UFCA FLORIDA GULF COAST HOSPITAL
Outpatient Rehabilitation & Diagnostic Center
DIAGNOSTICS MRI
ADDITION

HCA Diagnostic Center MRI Addition Bid Addendum No. 1

Date: 04/25/25

DAG Project #: 24107

A1 BUILDING SECTION
SCALE: 3/8" = 1'-0"

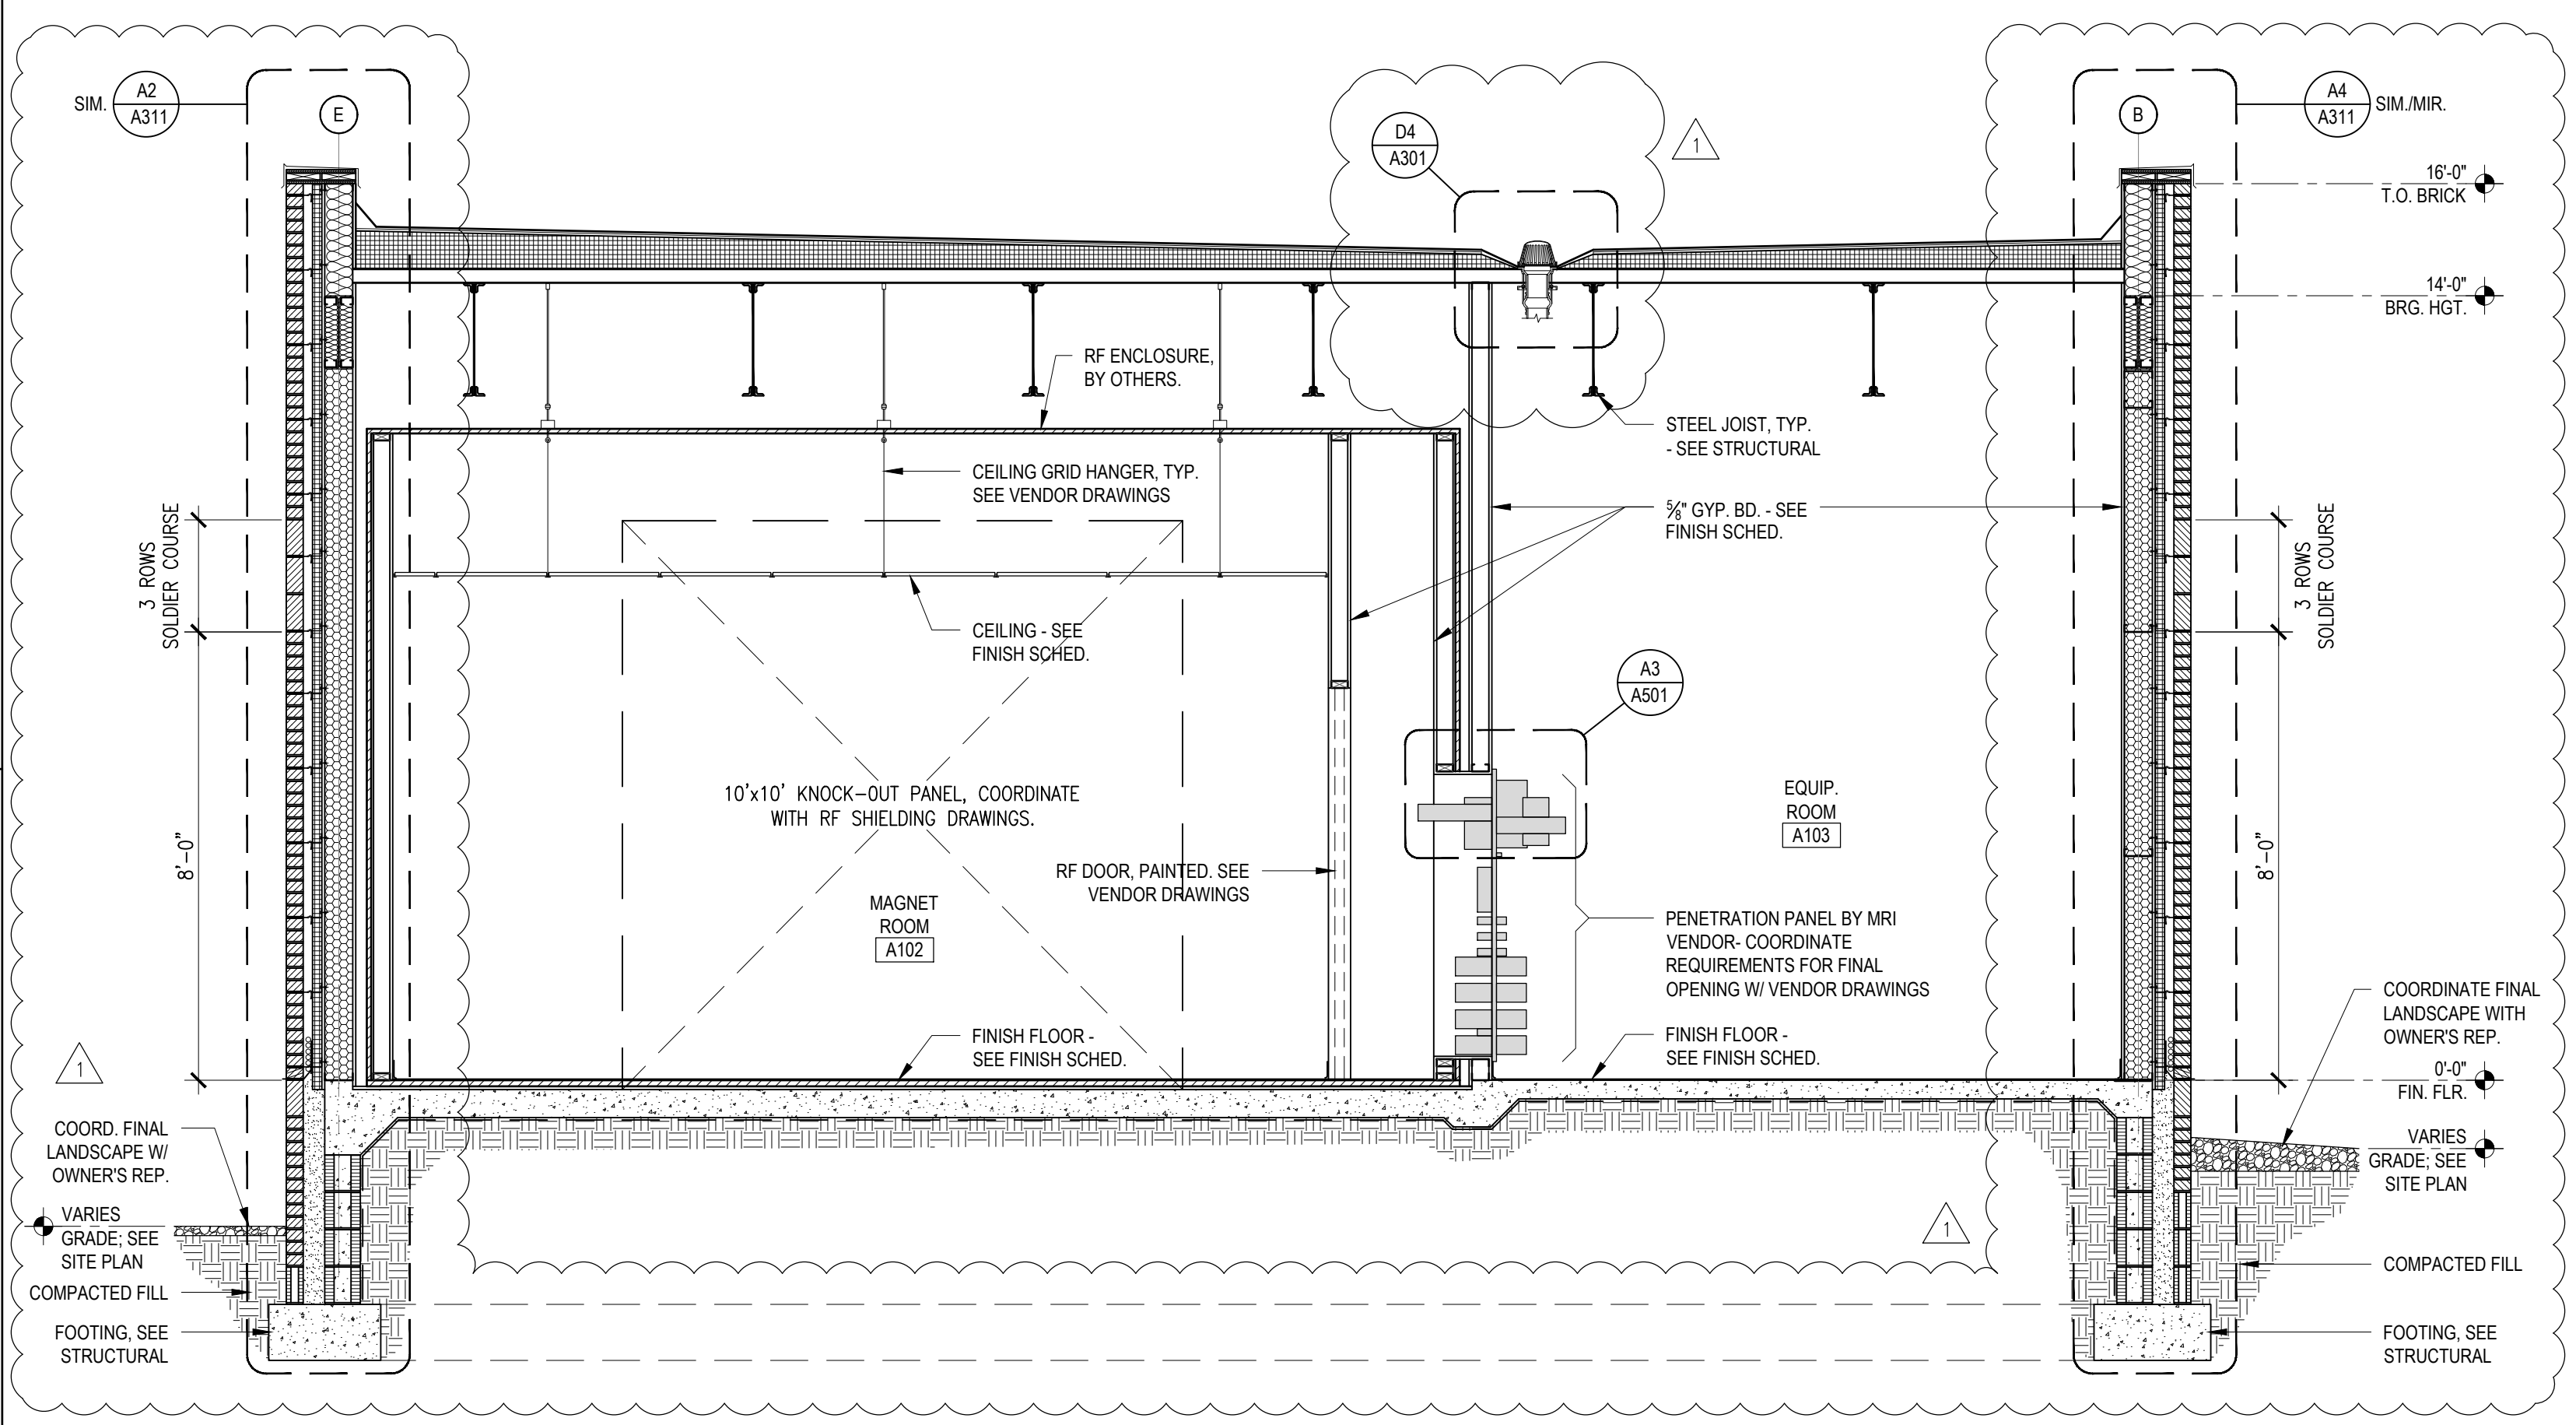
A-301 DETAIL A1

- ADDED WALL SECTION CALLOUTS "A2/A311 - SIM" & "A4/A311 - SIM"
- ADDED GRADE ELEVATIONS FROM SITE PLAN
- ADDED ADDITIONAL ROWS OF CMU TO ADJUST FOR ELEVATIONS
- ADDED GRAVEL LANDSCAPING
- ADDED HIDDEN LINES TO INDICATE FOOTERS IN BACKGROUND

A3 BUILDING SECTION
SCALE: 3/8" = 1'-0"

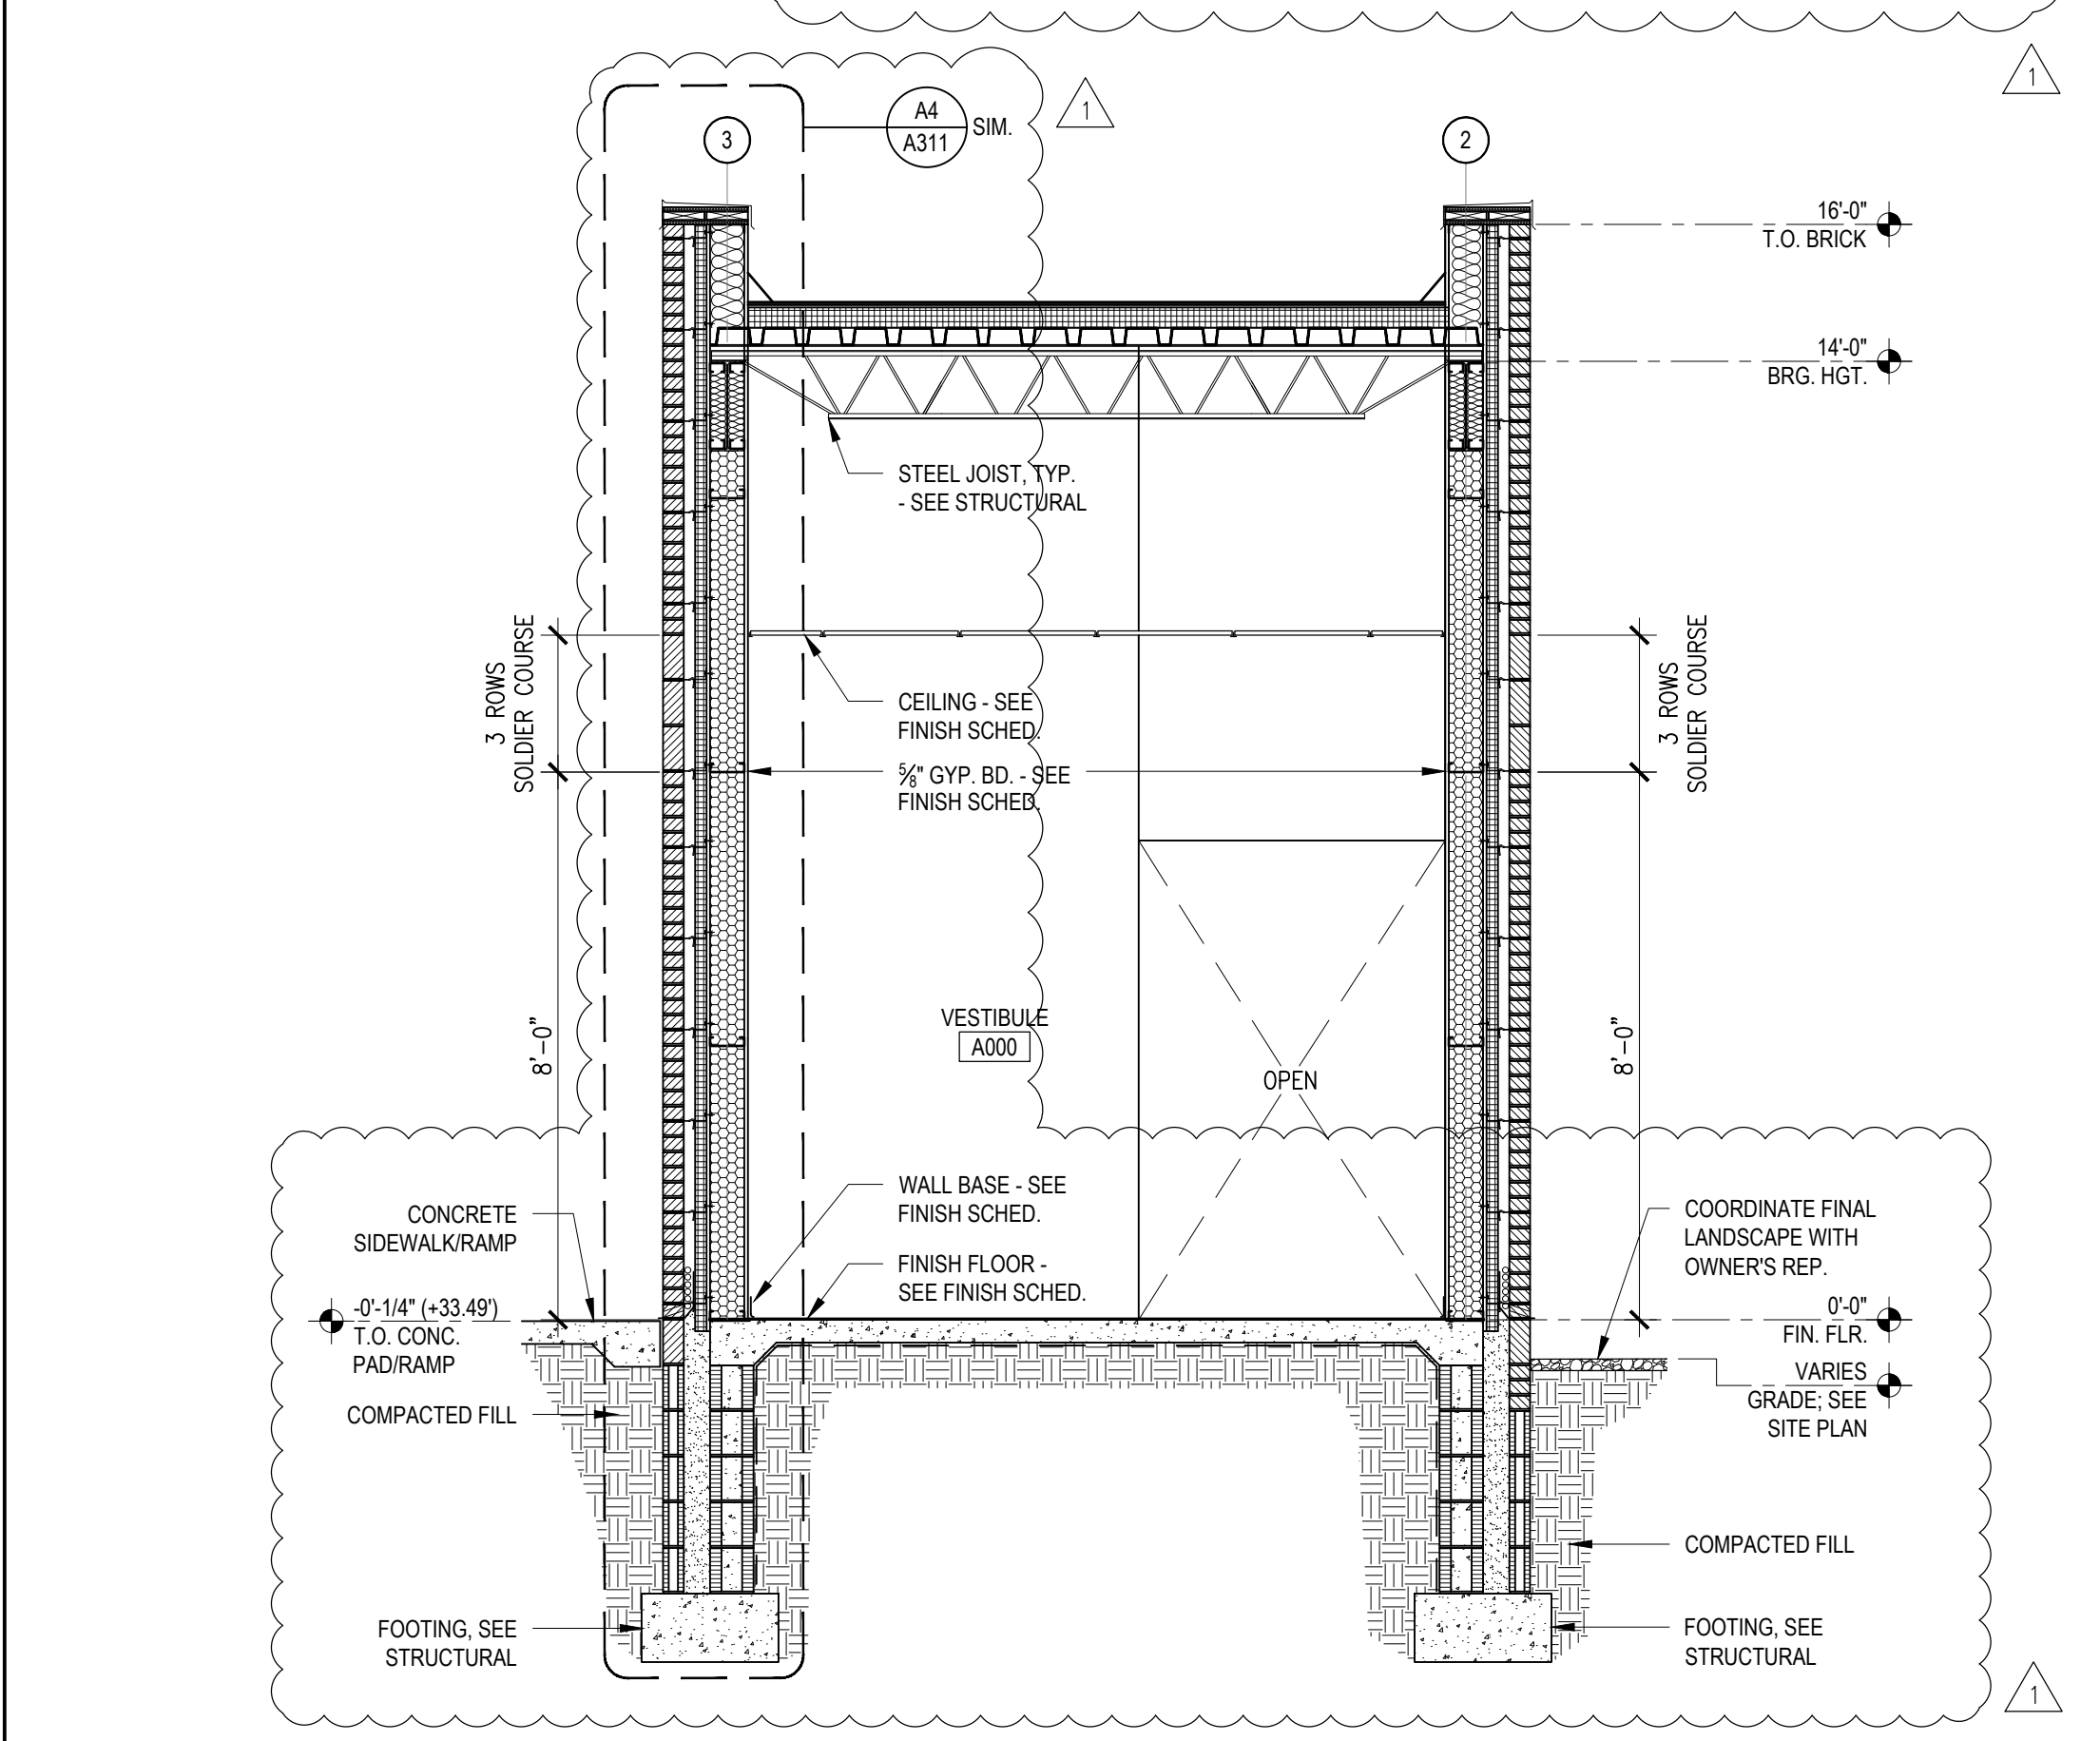
DETAIL A3

- ADDED WALL SECTION CALLOUTS "A4/A311 - SIM"
- ADDED GRADE ELEVATIONS FROM SITE PLAN

- ADDED NEW CONCRETE PAD BY SOUTH WALL & APPROPRIATE ELEVATION MARKER
- ADDED ADDITIONAL ROWS OF CMU TO ADJUST FOR ELEVATIONS
- ADDED GRAVEL LANDSCAPING

1 TYPICAL EXTERIOR PIPING SUPPORT DETAIL
M-203 SCALE: NONE

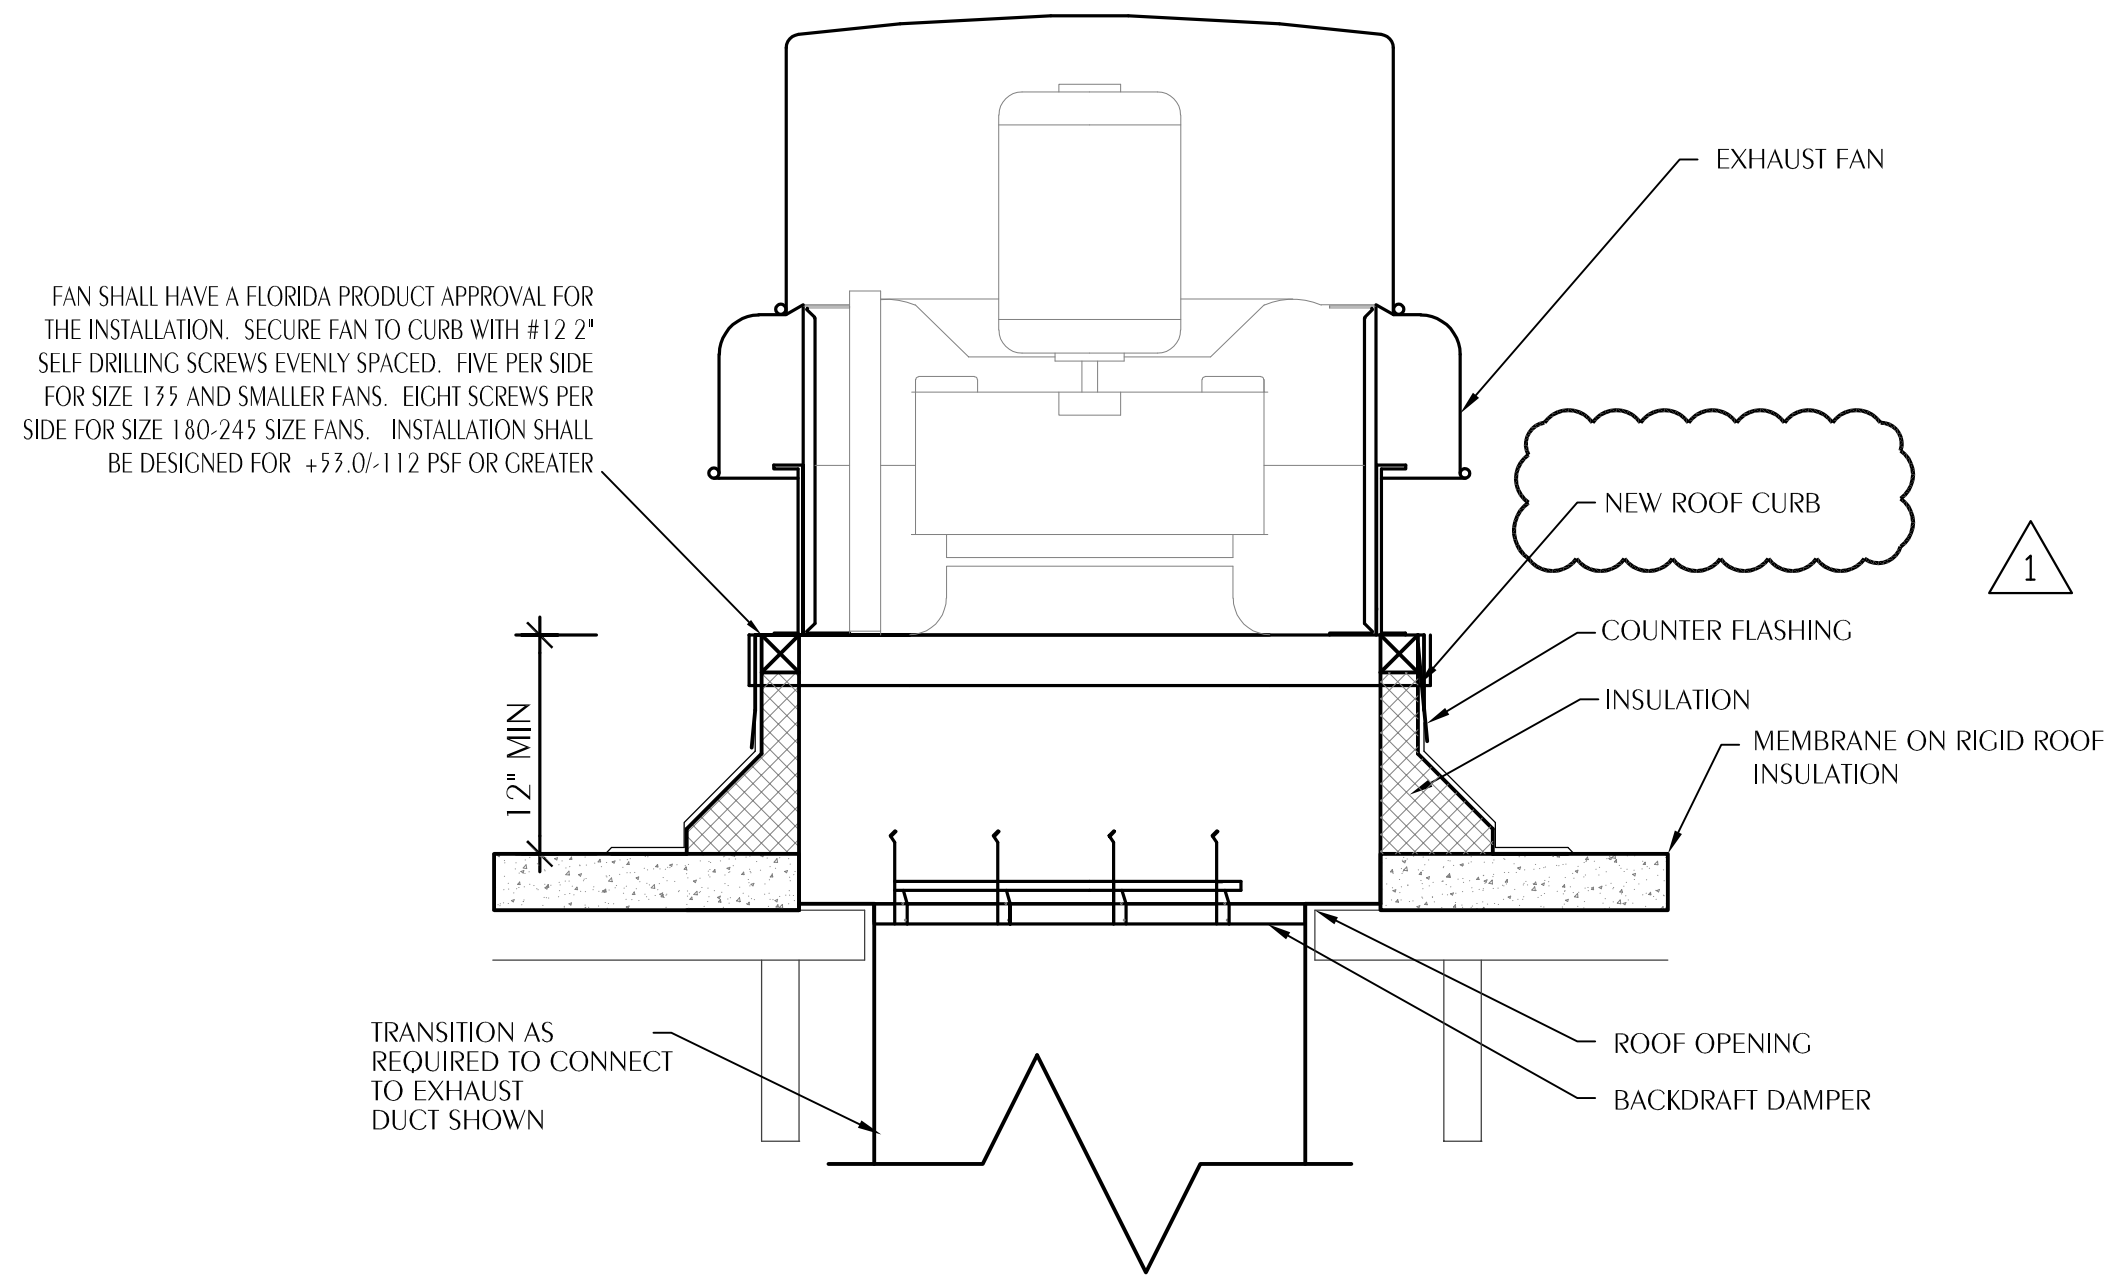
Q: M-101- Are refrigerant lines to HP-1 to be under or above ground? Please provide detail/product specification.

A: The intent is for the refrigerant to be above ground. Refer to detail 1/M-203
